#### TOWN OF WELLINGTON PLANNING COMMISSION July 10, 2023 6:30 PM

Subject: Site Plan Review - Lot 3, Block 1, Bonfire Subdivision, 2nd Filing (8761 Bonfire Drive)

# LOT 3, BLOCK 1, BONFIRE SUBDIVISION SITE PLAN:

## **PROPOSED SITE PLAN:**

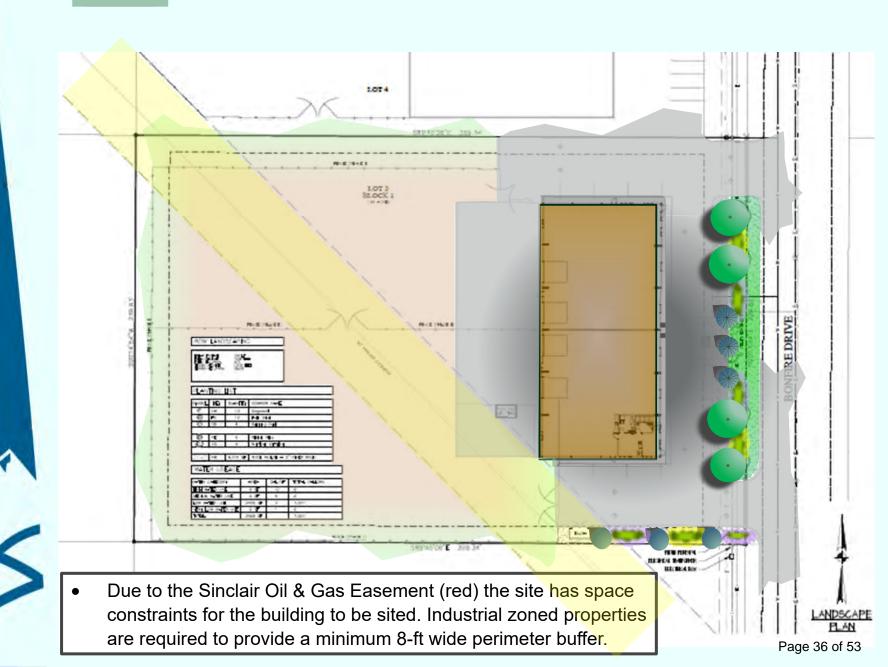
- <u>5. Parking</u>: Light Industrial uses are required to provide a minimum of 1 parking space per each 1,000 sq. ft. of gross floor area. The proposed building will consist of 10,500 sq. ft. of floor area, so (11) parking spaces are required. The applicant proposes (13) parking spaces, exceeding the requirement.

- SIZE: Parking spaces are required to comply with the minimum width and depth requirement (8 ft. x 24 ft.) for parallel parking spaces, Table 5.05.12-1. The drawing needs to be adjusted to show parking spaces that comply with these minimum dimensions.

# **PHOTOMETRIC PLAN:**

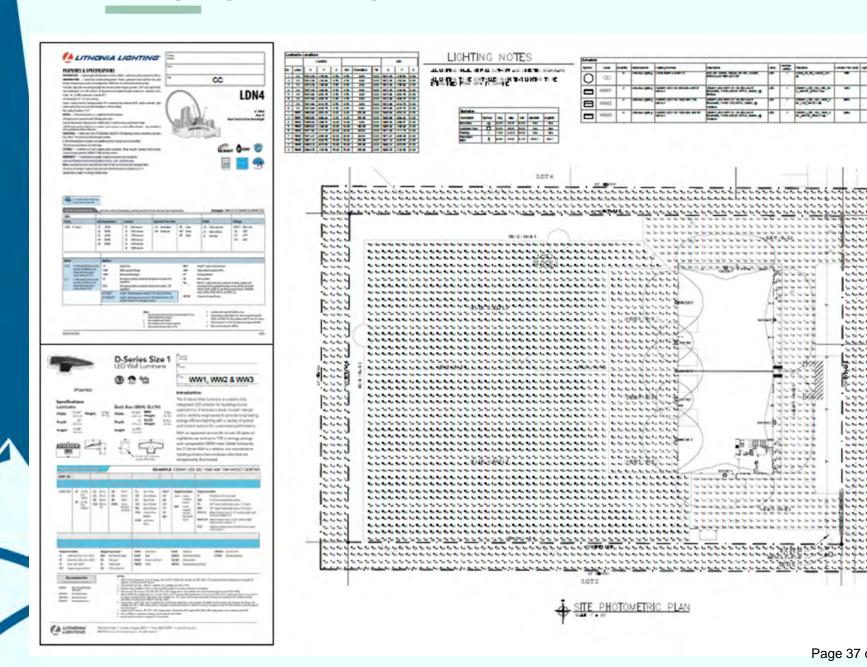
- 9. Site Lighting: A photometric plan was provided with the site plans as required.
  - The Town's maximum illumination level at the property line or 20-FT beyond, is 0.1 footcandle. The submitted plan complies with the 0.1 maximum illumination.
